RE: SES Solar One Project
 Applicant's Updated Project Map

**ACCESS ROAD
OPTION ONE
SOLAR ONE PROJECT**

**APPLICATION FOR CERTIFICATION
For the SES SOLAR ONE PROJECT**

Docket No. 08-AFC-13

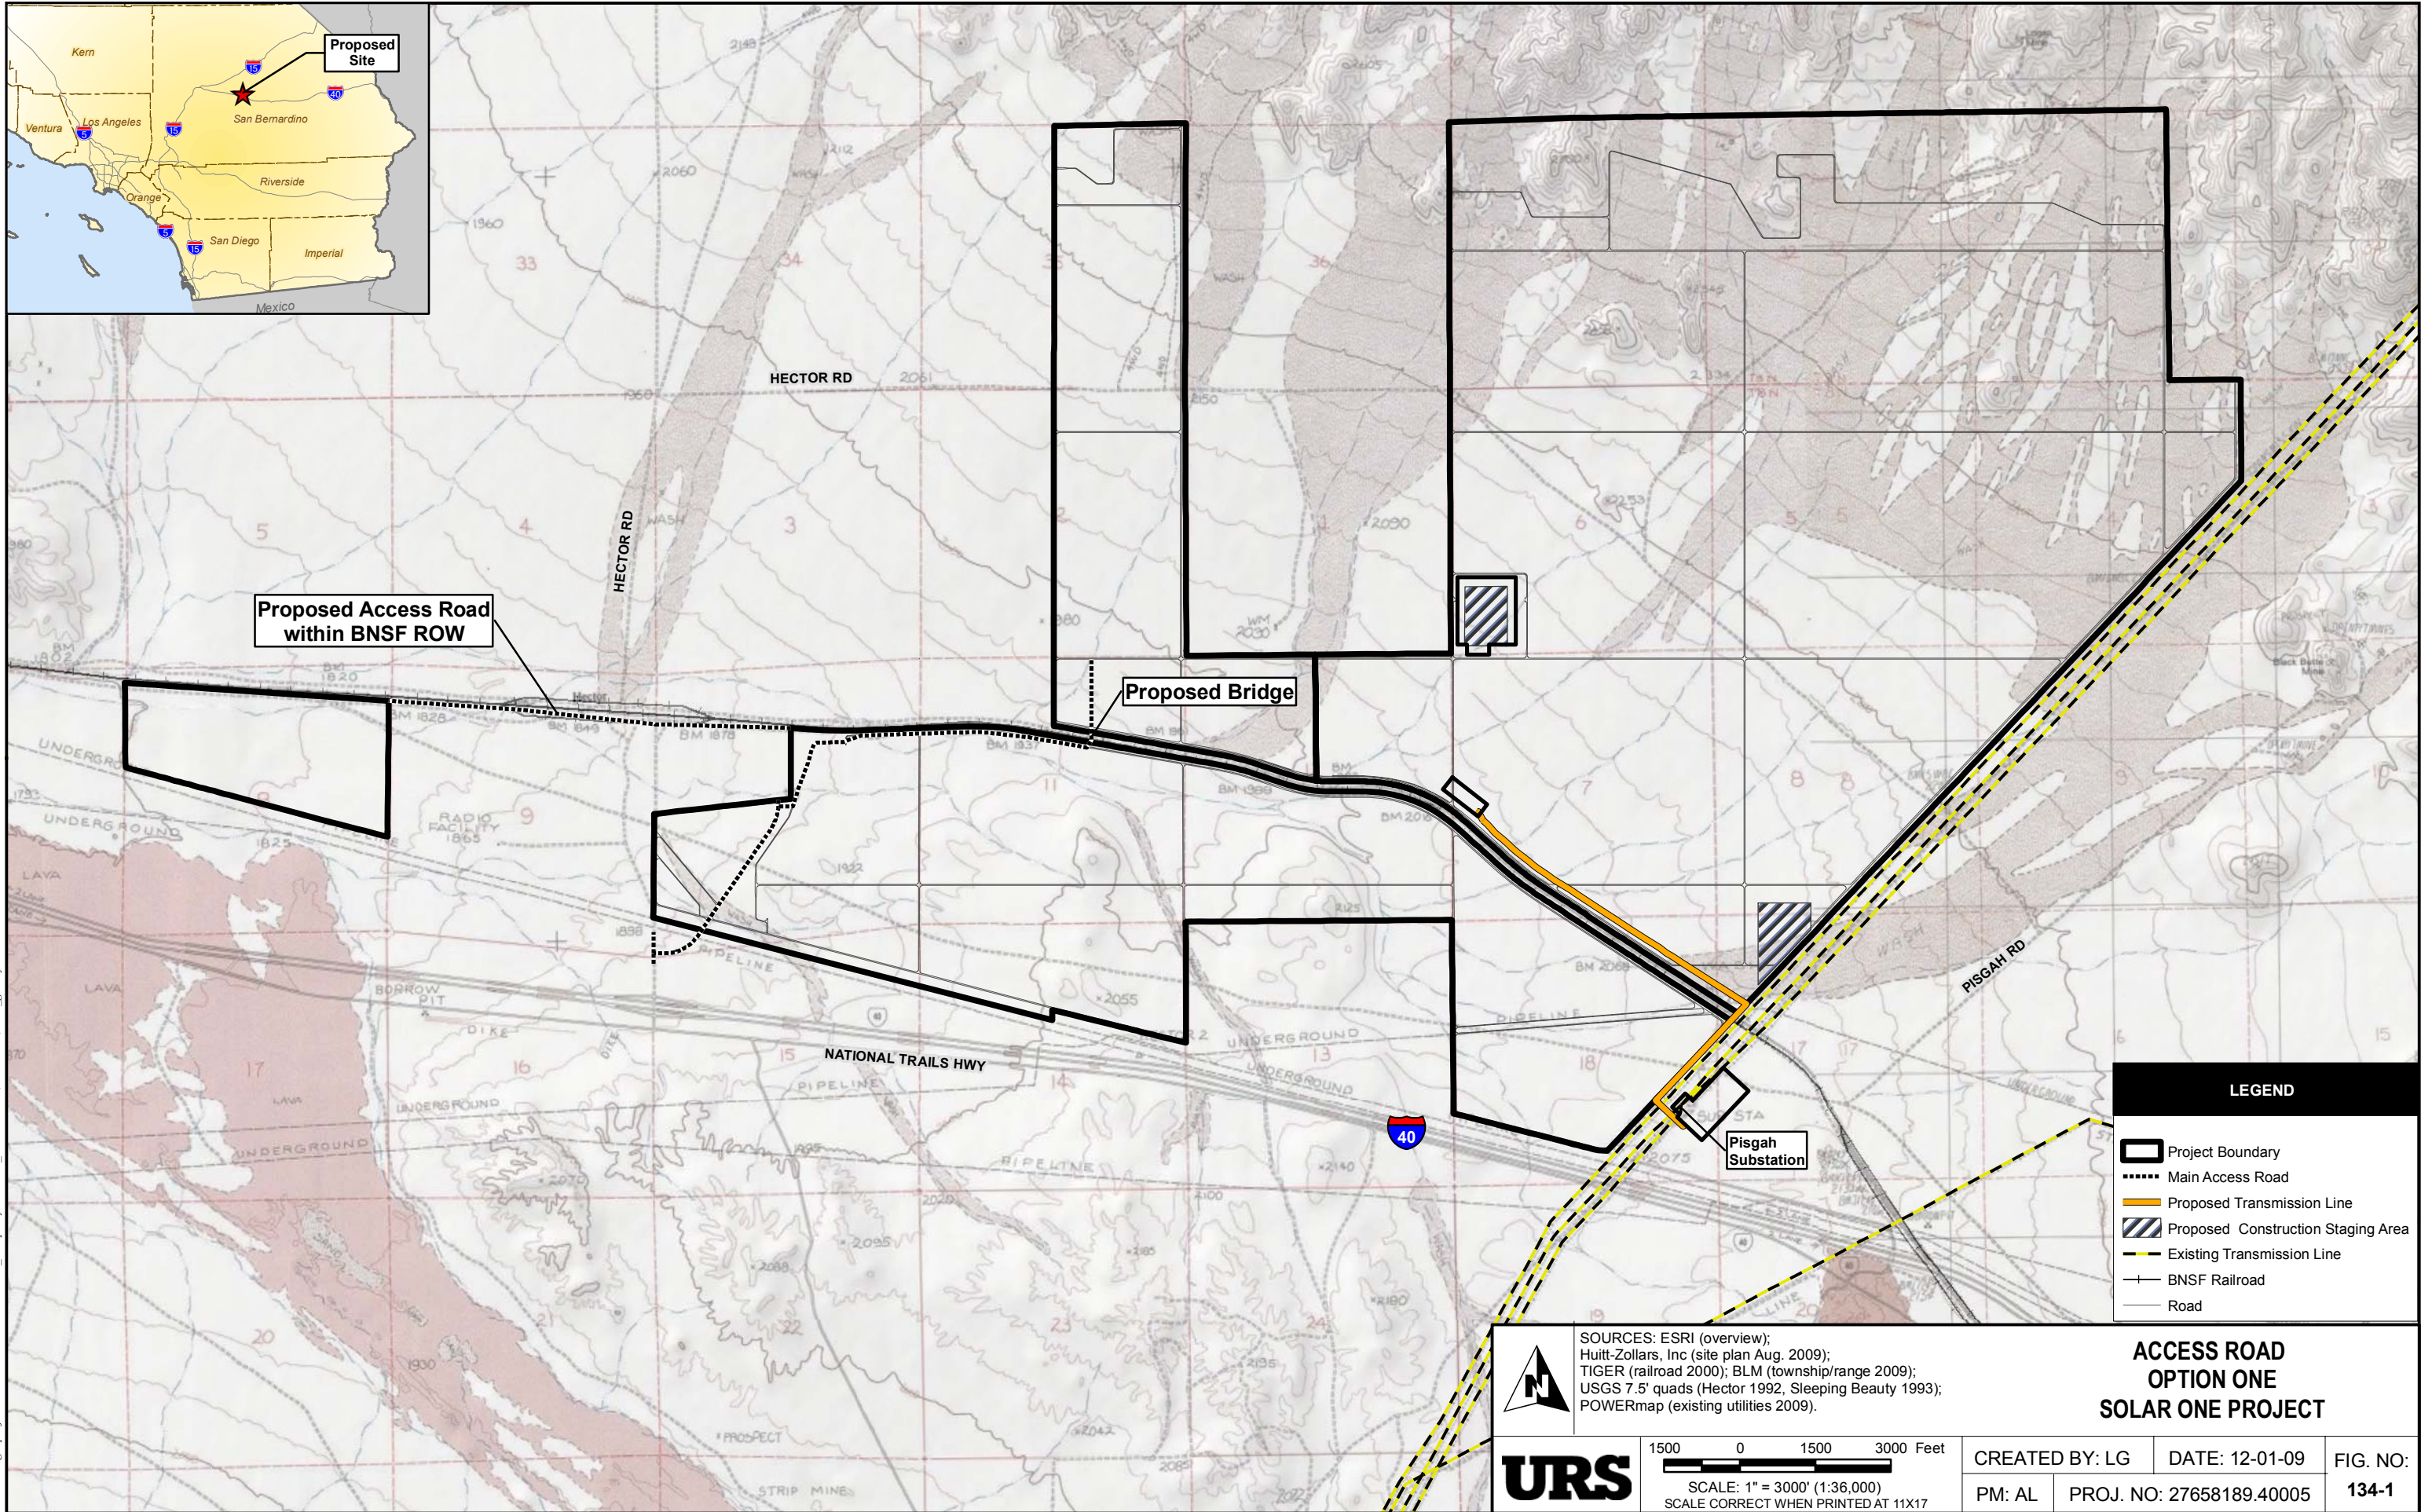
Tessera Solar, on behalf of the Applicant, hereby submits an updated Project Map for the Solar One Project (provided as Attachment 1). As demonstrated on Attachment 1, an access road will be built along BNSF right-of-way, leading to the south-western most portion of the Project site. An authorization letter from BNSF is provided as Attachment 2. A summary table of Project modifications associated with this map and previously discussed during the discovery phase of the Project's environmental review is presented below.

PROJECT MODIFICATION	REASON FOR MODIFICATION
Project Boundary Update and inclusion of access road through BNSF Right-of-Way to access the south-western most portion of the site (discussed herein)	<ul style="list-style-type: none"> • Needed to provide access to the Section which would otherwise be isolated by the sections which are not a part of the Project
Move Solar One Main Access Road and Bridge so that it is within the Project site boundaries (discussed herein)	<ul style="list-style-type: none"> • Reduce off-site impacts associated with the Project
Project Phasing – through consultation with agencies and the public, the Applicant is working to develop a phasing plan that minimizes environmental impacts, where practical. The previously utilized Phase I and Phase II label refer solely to geographic locations (above and below the railroad, respectively) and may not be temporally-significant (discussed in the response to CEC and BLM Data Request 135)	<ul style="list-style-type: none"> • Minimize environmental impacts, where practicable
